**STAFF RECOMMENDATION**

**1419 Holly Street**

**July 18, 2012**

**Application:** Demolition and New construction-primary building

**EXISTING BUILDING**

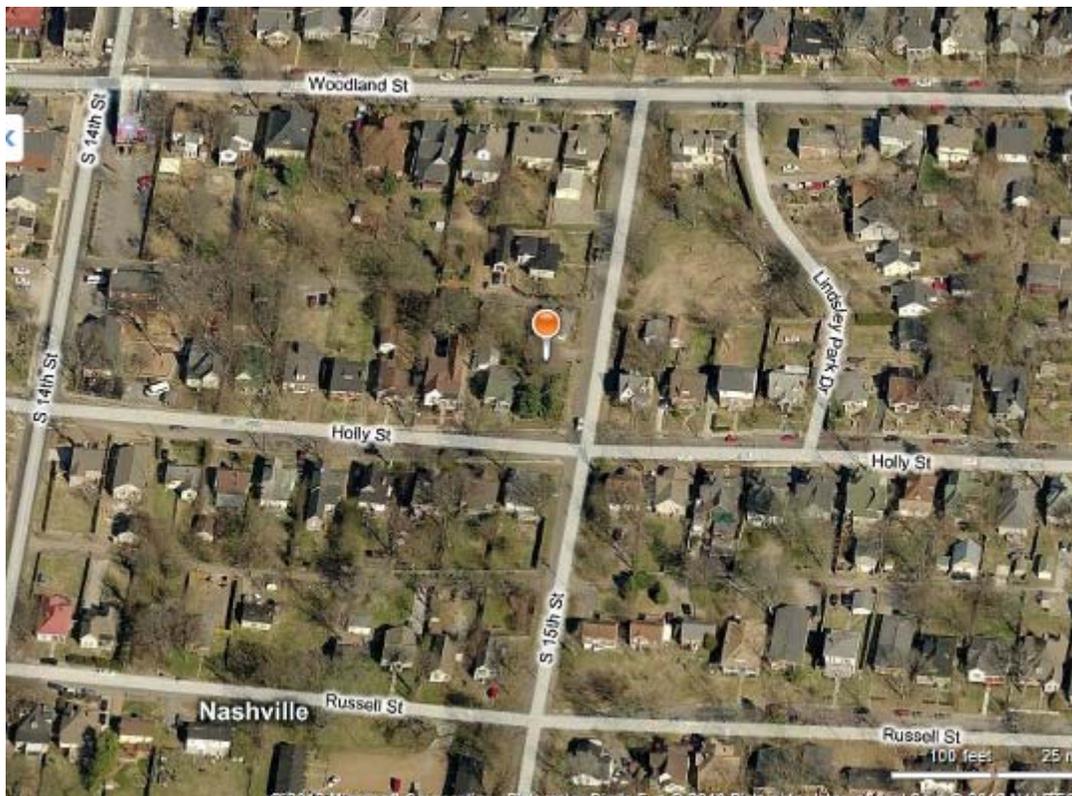
Demolition: This lot has been empty, at least since 1914. (See 1914 Sanborn Fire Insurance map to the right.) At the rear of the lot sits a c.1950 secondary dwelling that has undergone multiple alterations. It first appears on the Sanborn Fire Insurance maps and in the city directories in 1951. The foundation is concrete block, the siding Masonite and the roof asphalt

shingle. Since it was constructed outside of the period of significance for the overlay and does not contribute to the historic character in terms of style or construction method, staff finds demolition is appropriate and meet section III.B.2.

**A1** SIDE(WEST) ELEVATION  
 SCALE: 3/16"=1'-0"

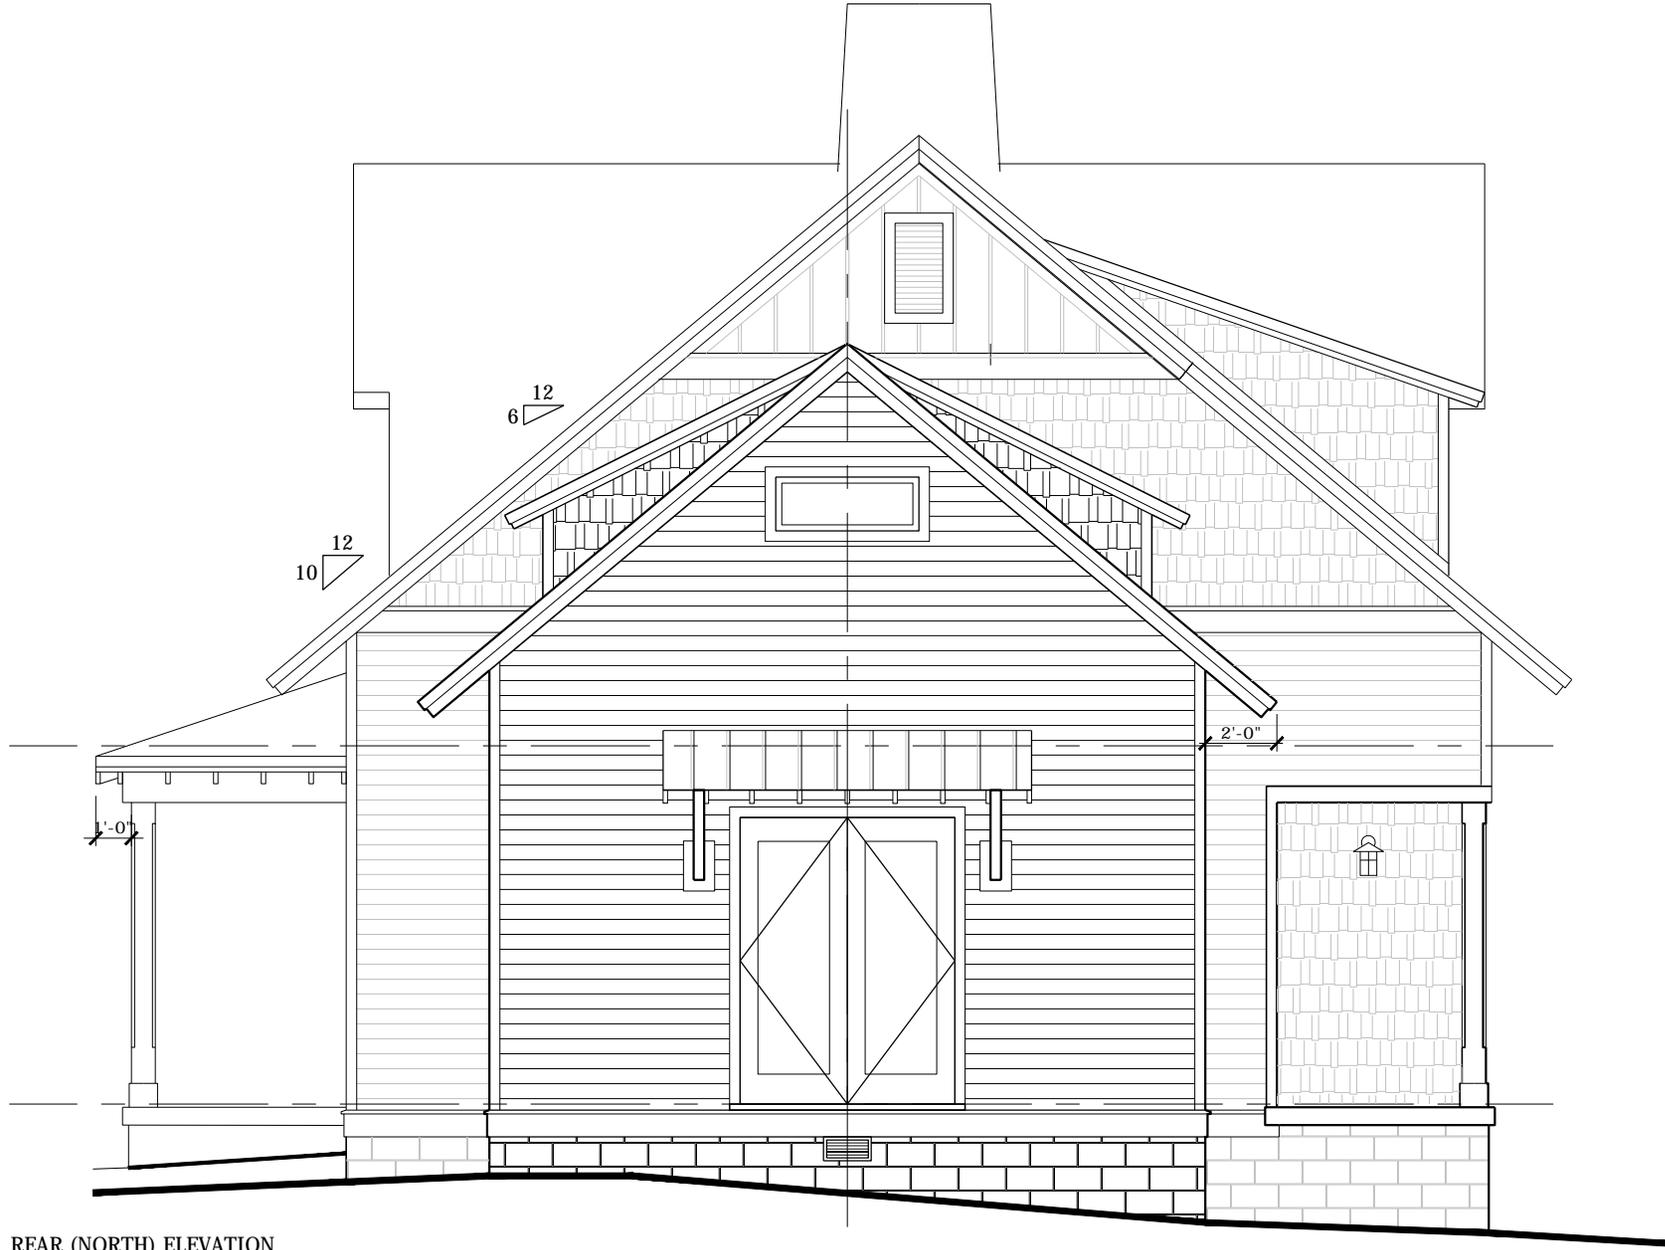
**Height & Scale:** The homes in the immediate context are mostly one and one-half story homes that range between seventeen and twenty-six feet (17'-26') tall from grade. The proposed building is also a one and one-half story building that varies in height due to the grade. The front, which faces Holly Street, will range between approximately twenty nine feet and thirty one feet (29'-31') from existing grade, which is a foot lower than the last time this house was presented to the Commission. Staff believes the house could be lowered another foot and so makes that recommendation to bring it closer to the context. The foundation height on the Holly Street side ranges between approximately two and three and one-half feet (2'-3.5') from existing grade to finished floor.

Staff recommends approval with the conditions that Staff provide final review of windows and doors and that the overall height of the house be lowered by one foot (1'). With this condition, the project meets section II.B for new construction in the Lockeland-Springs Neighborhood Conservation Zoning Overlay.

**A1** ARCHITECTURAL SITE PLAN  
SCALE: 1/16"=1'-0"

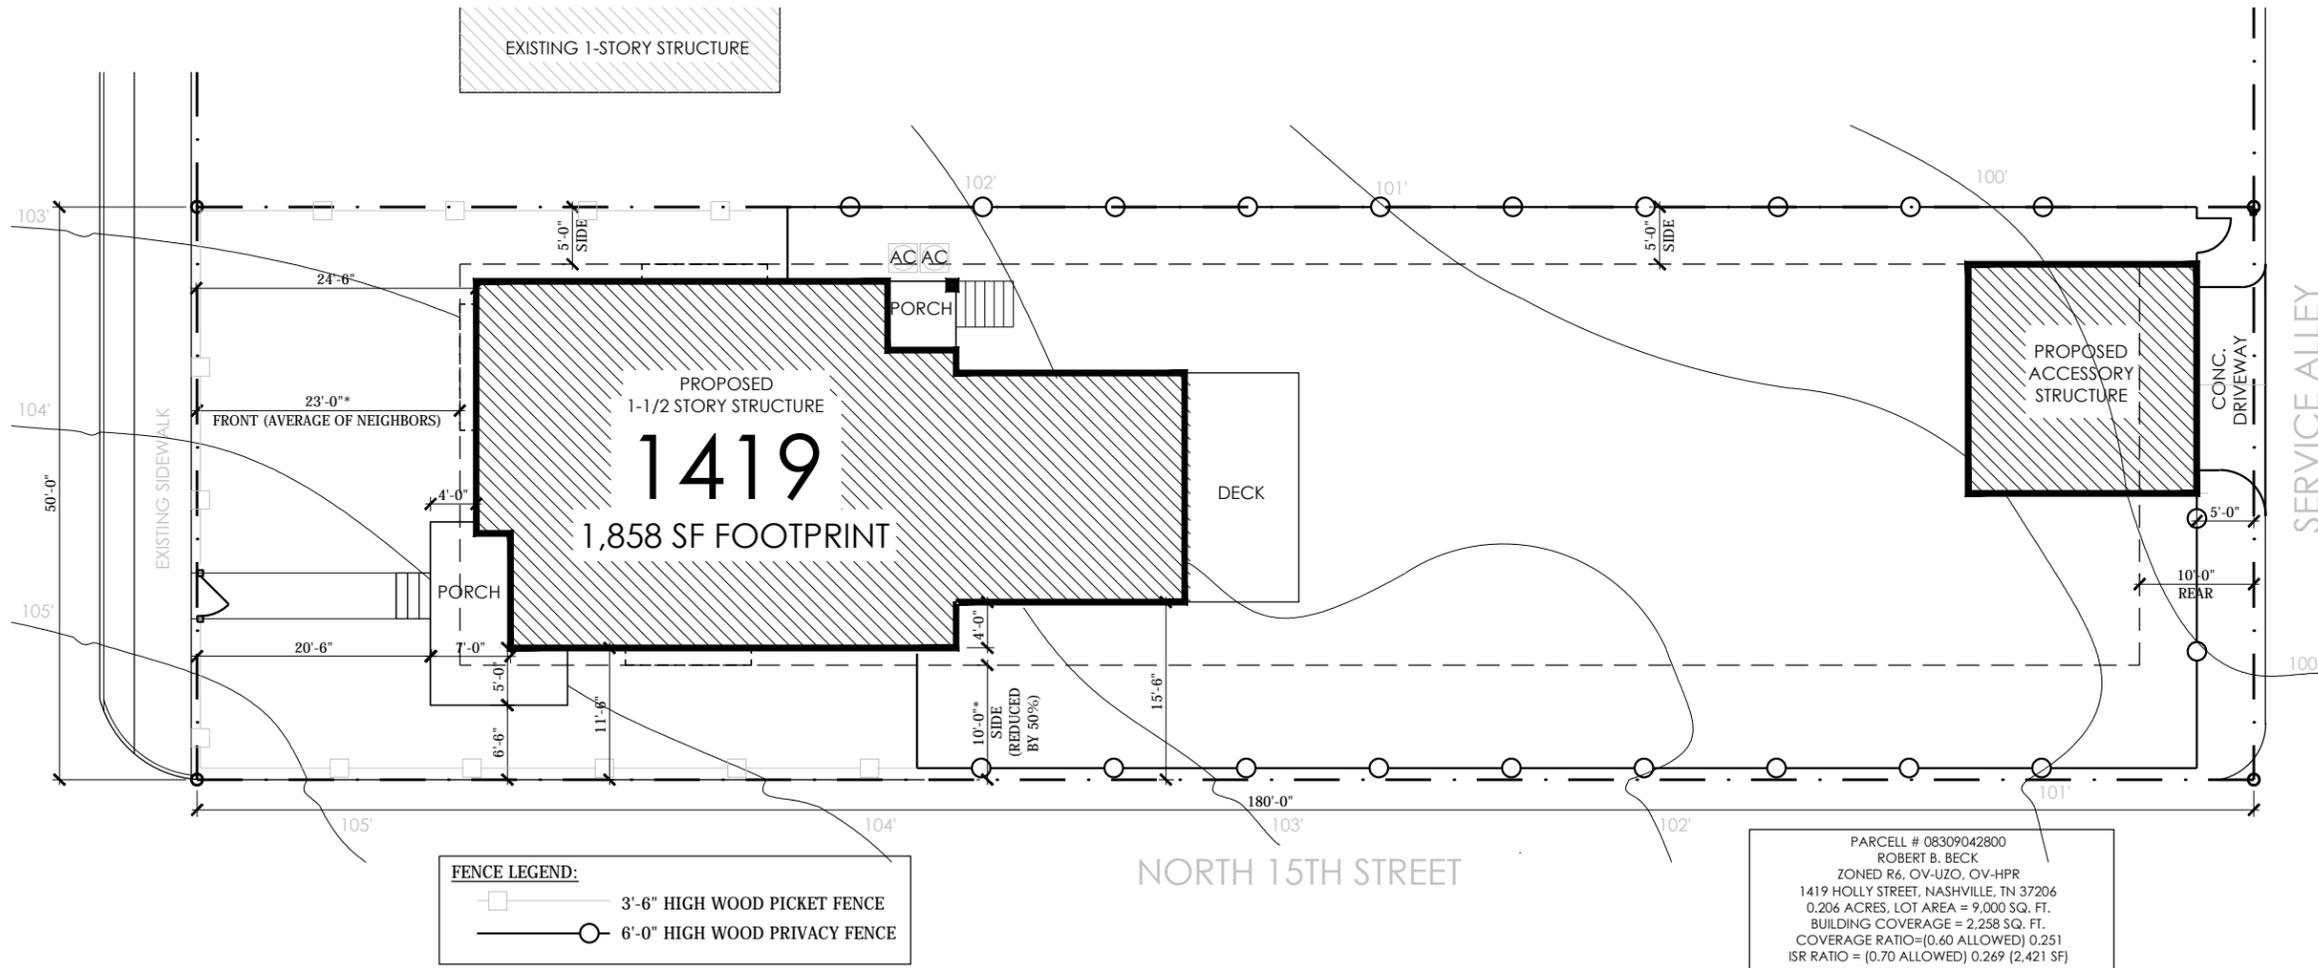
**Location, Setback and Rhythm of Spacing:** The width of the historic buildings in the area range between thirty and thirty-five feet (30'-35') and the homes are roughly centered on the lot. The width of the proposed is approximately thirty feet (30') and so meets the context. The porch that extends into the setback is appropriate since the historic context exhibits sides of corner buildings being as close as approximately five feet to the street. Staff finds that the setback reduction and rhythm of spacing meets section II.B.3.

Appurtenances: The mechanicals are located on the interior lot line side beyond the midpoint of the house and so are located in an appropriate location. A three foot, six inch (3'6") wooden picket fence will encircle the front of the property with a six foot tall (6') wood privacy fence around the rear of the property. Small lights are located to either side or over entrances.

**A1** ALLEY ELEVATION  
SCALE: 3/16"=1'-0"

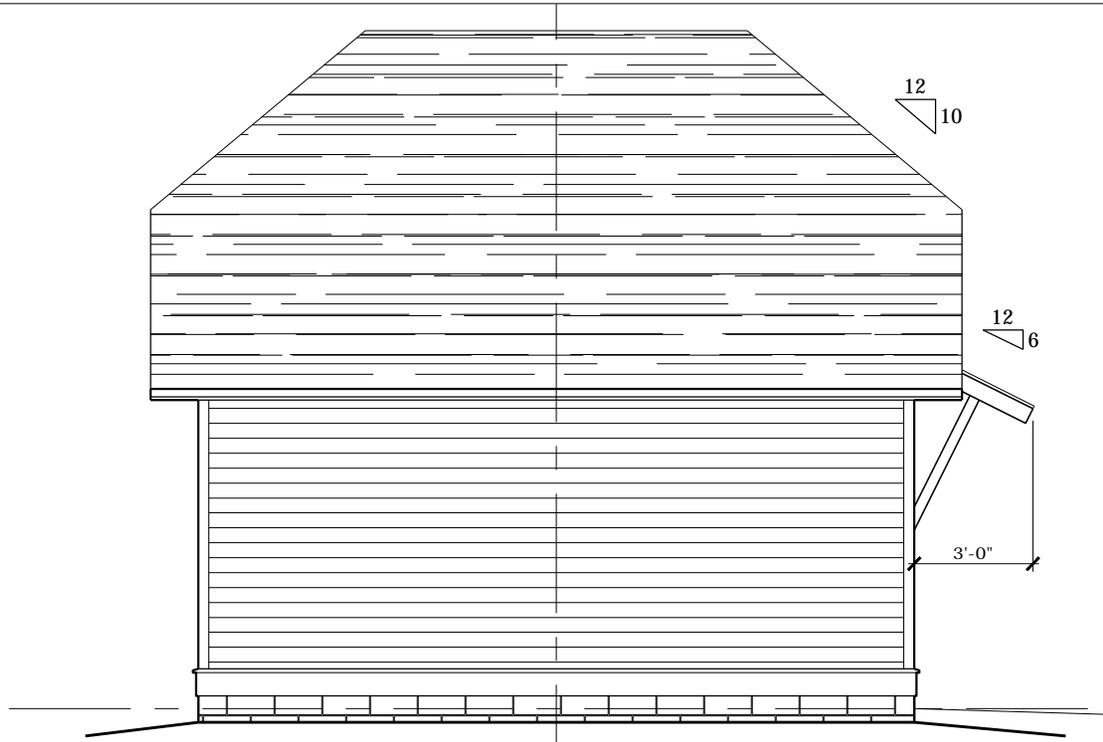
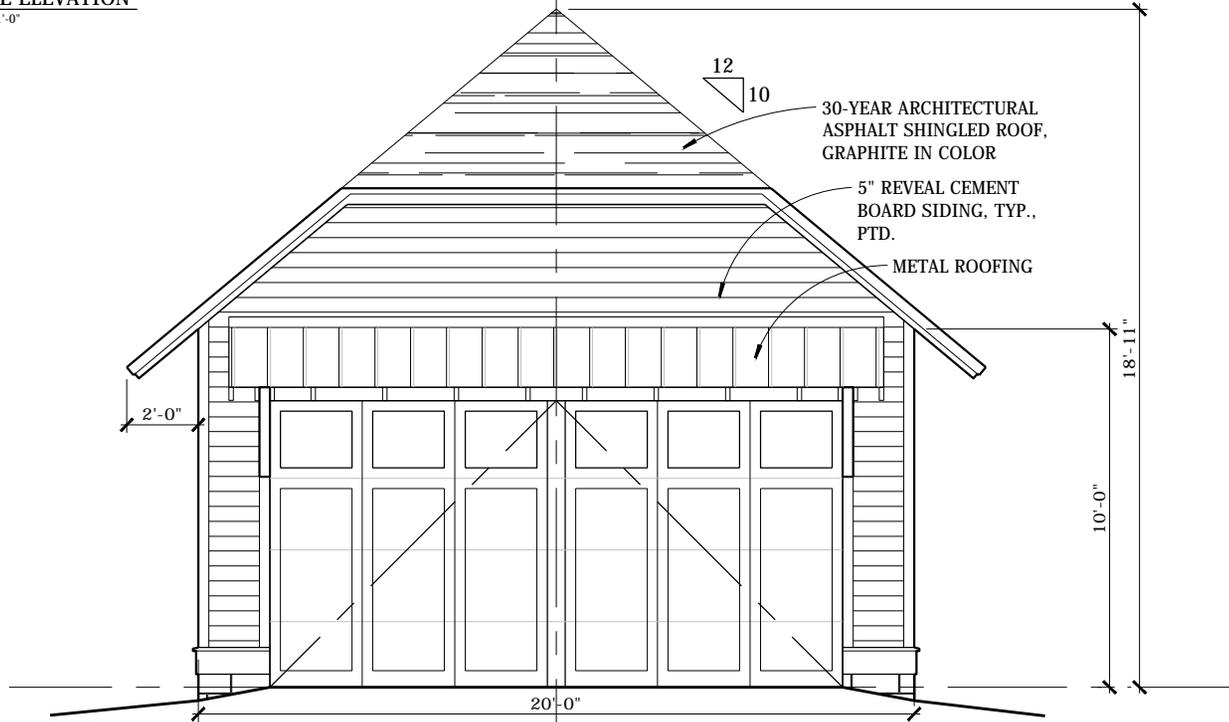
Outbuildings: The design guidelines state that garages visible from the street should be located in historically appropriate locations. For this neighborhood, historic garage locations are near the alley, when present. The proposed garage is located on the alley and towards the interior lot line, which is an appropriate location.

The garage is subordinate to the primary dwelling as it is approximately nineteen feet (19') tall from finished floor, compared to the primary dwelling which is approximately twenty seven feet (27') tall from finished floor level. In addition it has a footprint of four-hundred square feet (400 sq. ft.) compared to the eighteen hundred and fifty eight square feet (1858 sq. ft.) of the primary building. The design and materials of the garage will match the existing house. Staff finds the project to meet section II.B.8.
